## Planning & Development Services

# Appeal of DB-11-38 SPL Development Plan Review to allow conversion of an existing office space to a bar with an associated outdoor cafe.

Legistar 110147H

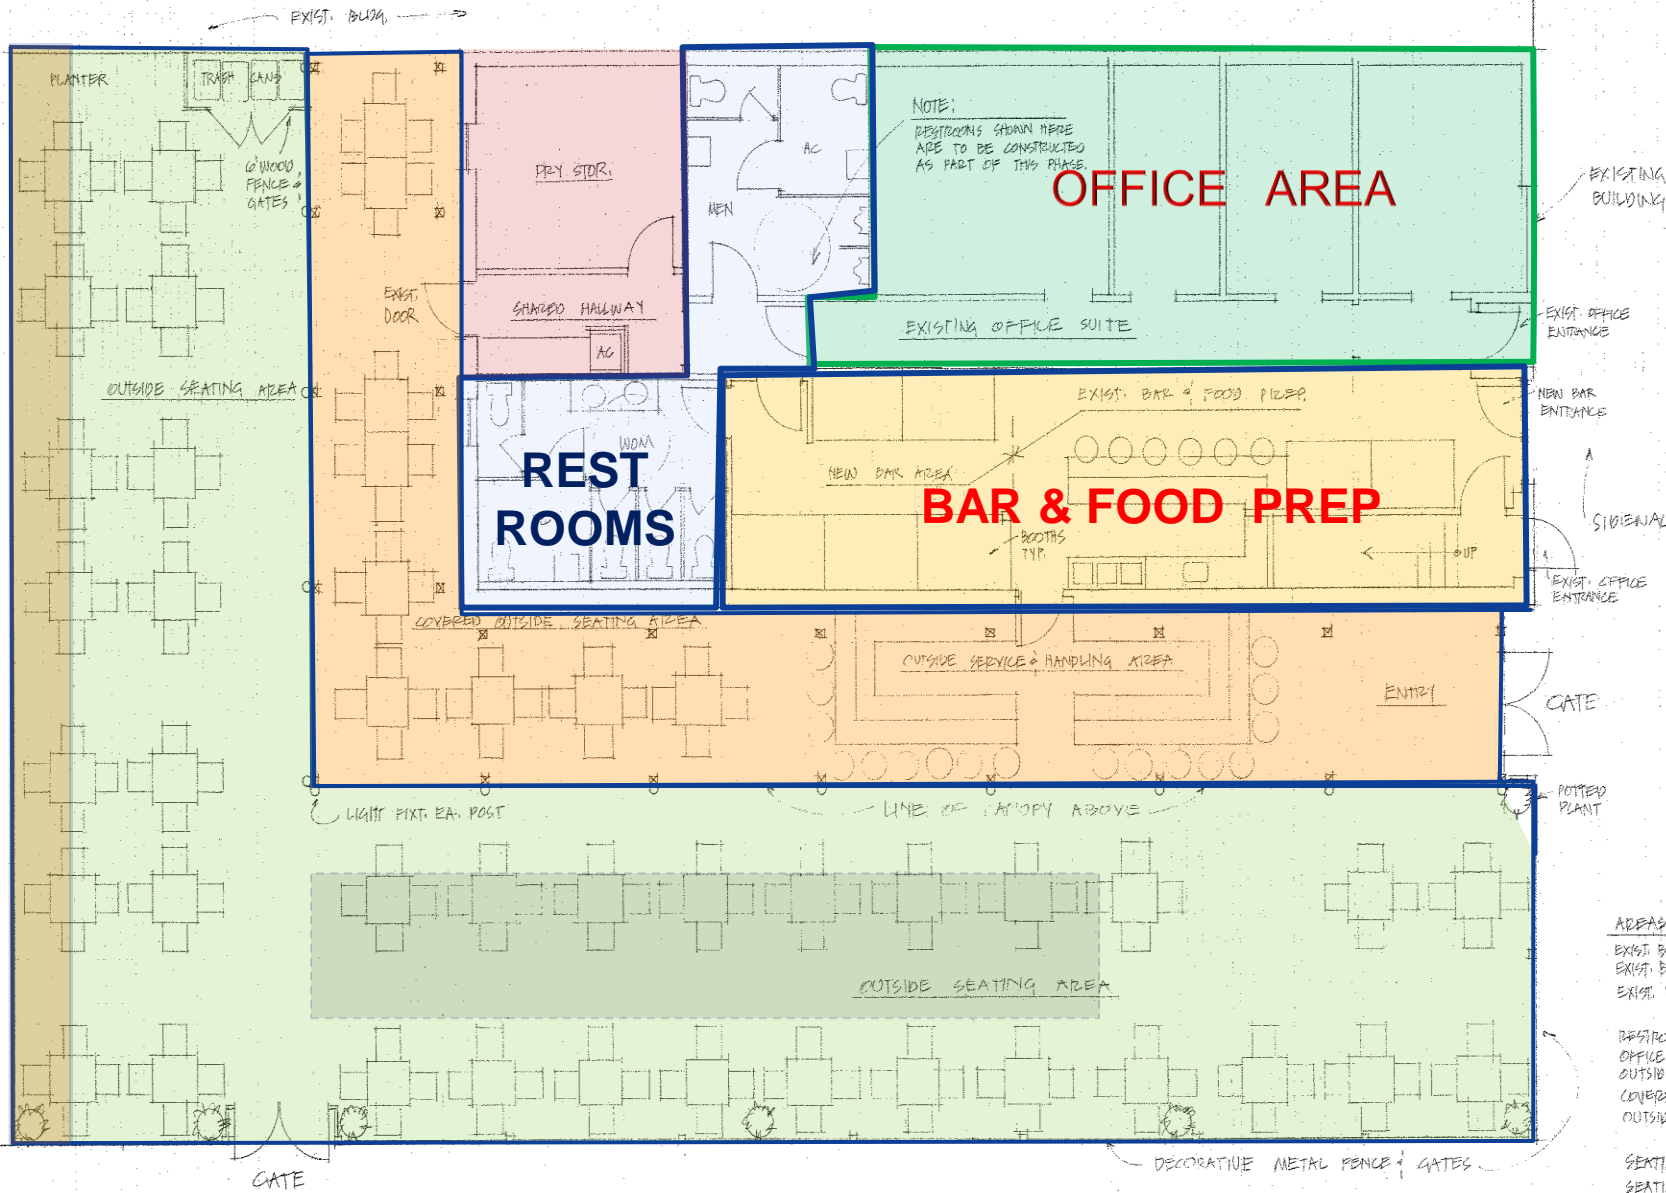
2. Fencing around the outdoor café shall be consistent with the fencing types in the downtown area and shall not exceed a maximum height of five (5) feet, as shown on the development plan. The type of fencing materials may be aluminum or wrought iron; other types of fencing consistent with the downtown are also acceptable. The door swing on the plans should not extend into the public right-of-way.

3. The plans show a roof deck above the canopy on the south side of the building; that area is not approved with this petition and shall not be used. No details, access or indication of intended use has been provided for the deck shown on the plans; any future use of said area will require siteplan modification in accordance with the Land Development Code before the Development Review Board.

4. The glazing proposed on the development plan shall not be less than the glazing currently existing on the building façade.
5. Label the floor plan to show the use of each area including the ingress/egress accessways to each use.

# Non-conforming Facade

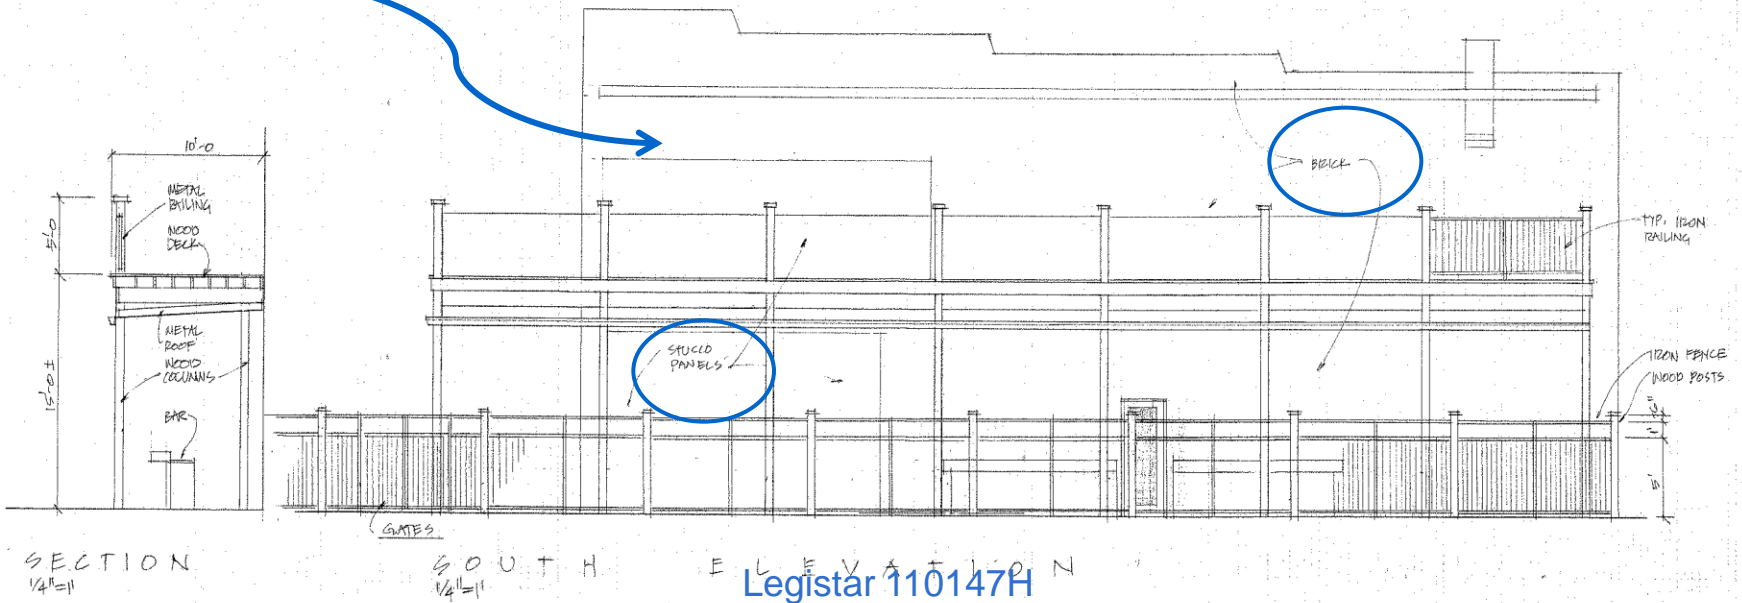
1. The project is an intensification of a non-conforming condition and does not conform to the City of Gainesville's Code and the Comprehensive plan.
2. The project does not comply with the intent of Policy 3.5.6 of the Urban Design Element of the Comprehensive Plan.

- 3. The project does not comply with the intent and word of the “Special Area Plan overlay district for the Traditional City”.**
  - a. Buildings located close to the street**
  - b. Articulated building walls**
  - c. Aligned building façades and d. build-to lines**
  - e. non-conforming building may not increase the degree of non-conformity**
